ADDENDUM NO. 2

To: Invited Bidders
Project: **St. Mary Fort Walton Beach Admin Building & Renovation**
Fort Walton Beach, Florida
Date: May 19, 2026 Bid Date: May 21, 2026
Architect: Quina Grundhoefer Architects

E0.1

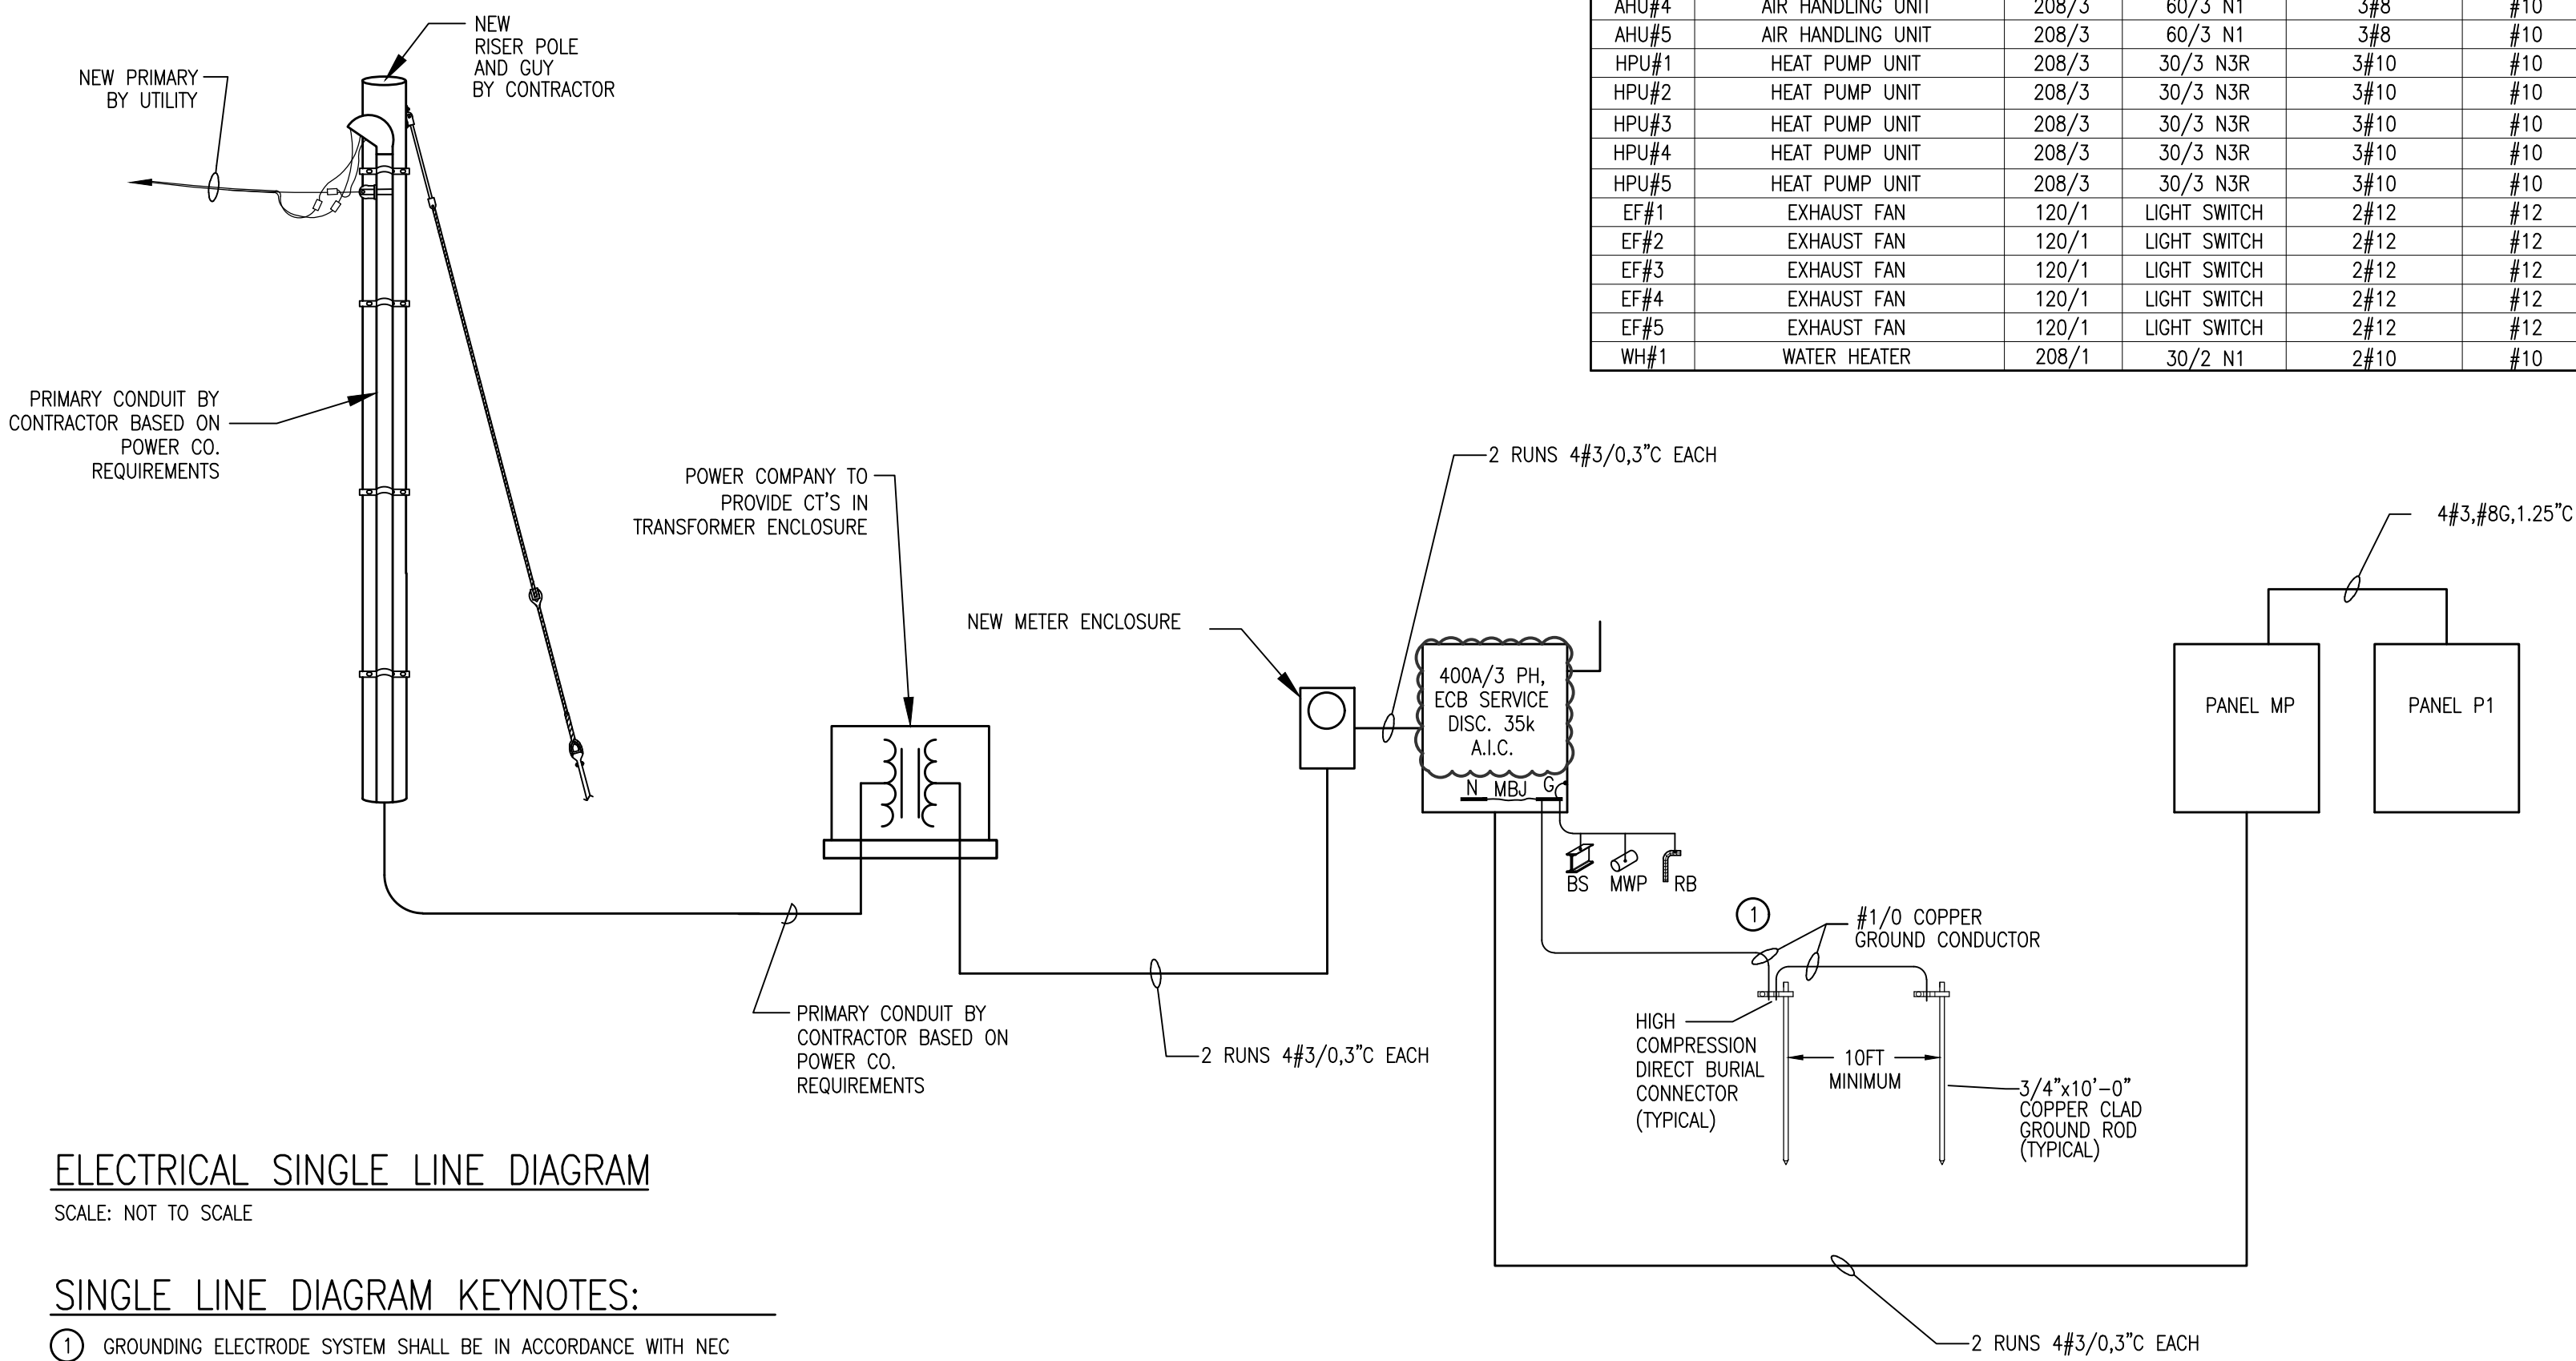
1. **Refer to Attached Revised Sheet E0.1:**
 - a. Changed A.I.C. rating to 35,000 amps in the panel schedules.
 - b. Added the E.C.B. A.I.C. rating to the riser diagram.
 - c. Added a circuit to the panel schedule for a surge protection device required at the main panel.
2. **Refer to Attached Revised Sheet E2.2:**
 - a. Revised drawing to show wall clocks powered by 120V receptacle circuits.
3. **Clarification to Sheet E2.2:**
 - a. Owner to provide wall clocks.
